Special City Planning Committee Meeting

Monday, 5 July 2021

3.1 APPLICATIONS UNDER THE HOBART INTERIM PLANNING SCHEME 2015

- 1.1 Planning approval is sought for Two Multiple Dwellings (One Existing, One New), at 35 Lipscombe Avenue, 37 Lipscombe Avenue and 16 Lauramont Avenue, Sandy Bay.

Figure 2: The return view looking towards the site of the proposed development up the driveway of the adjacent site at 33 Lipscombe Avenue, as taken from one of the submitted representations. The markups, including the location of the proposed building have been added by the representor.

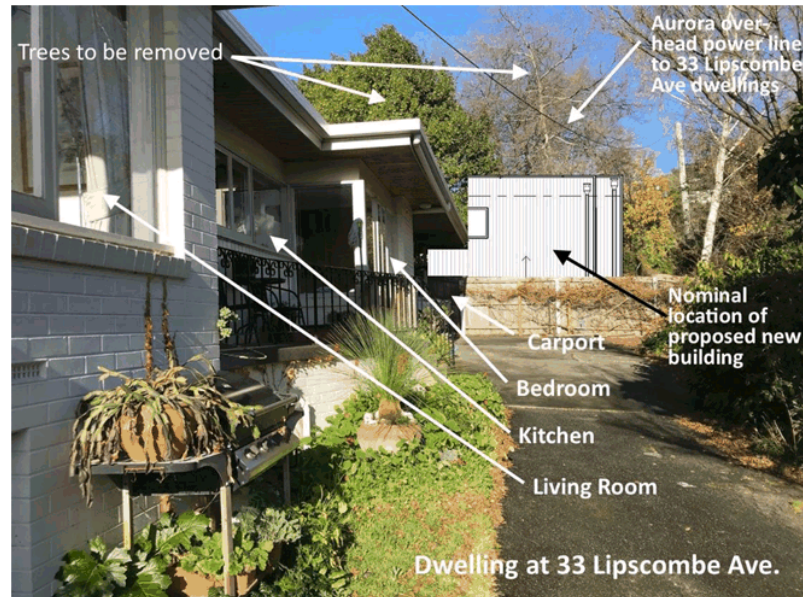
Plate 3: The adjoining property to the north of the proposed development (33 Lipscombe Avenue), where there is a driveway and carport opposite the site of the proposed dwelling. Windows further along the side of the adjacent dwelling do not have a direct outlook to the subject site/development.

The corresponding view back towards the proposed development has been provided by one of the representors in their submission, and can be seen in Figure 2, below.

Image 1: Landslide Hazard Area and subject lot

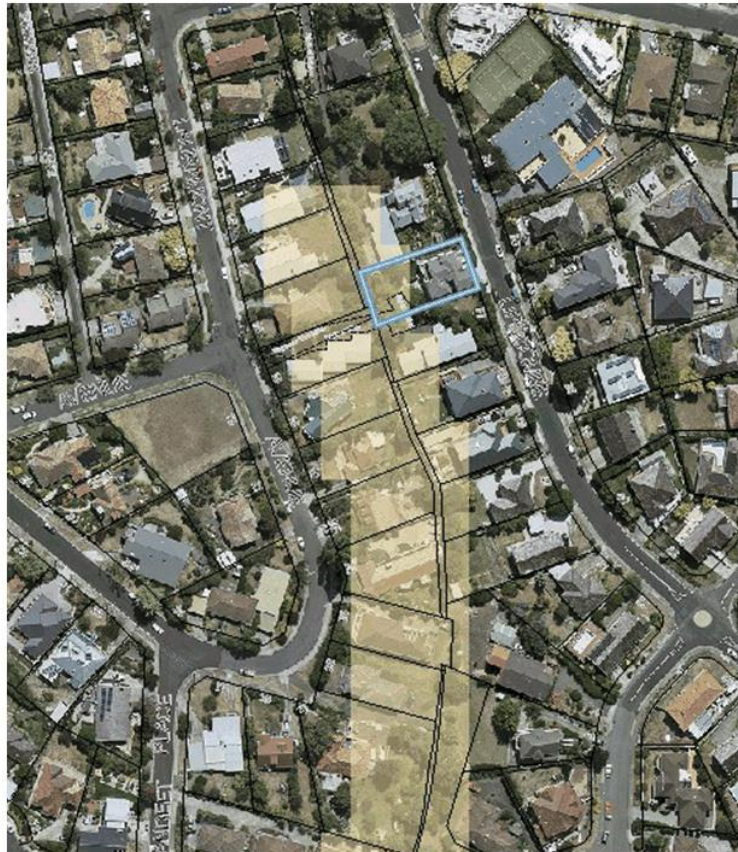
The Code applies because development is proposed within a Landslide Hazard Area (Low Landslide Hazard Area). The land is a Landslide Hazard Area because of modelled susceptibility to debris flow (runout area).

The proposed building itself is exempt from the Code standards pursuant to exemption clause E3.4(c), however associated works are not specifically exempted.

NORTH ELEVATION
 SCALE 1 : 100

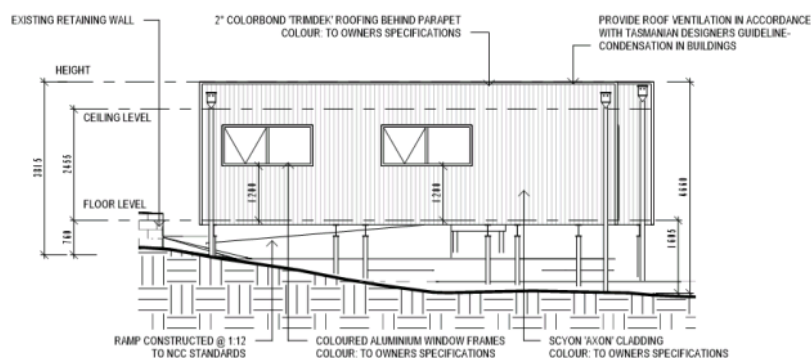
The dining/living room window in the northern elevation of the dwelling must be modified to reduce the potential for overlooking into the adjacent property to the north.

The dining/living room window in the northern elevation of the dwelling must be modified to reduce the potential for overlooking into the adjacent property to the north.

Prior to the issue of any approval under the *Building Act 2016*, revised plans must be submitted and approved as a Condition Endorsement showing:

Prior to the issue of any approval under the *Building Act 2016*, revised plans must be submitted and approved as a Condition Endorsement showing:
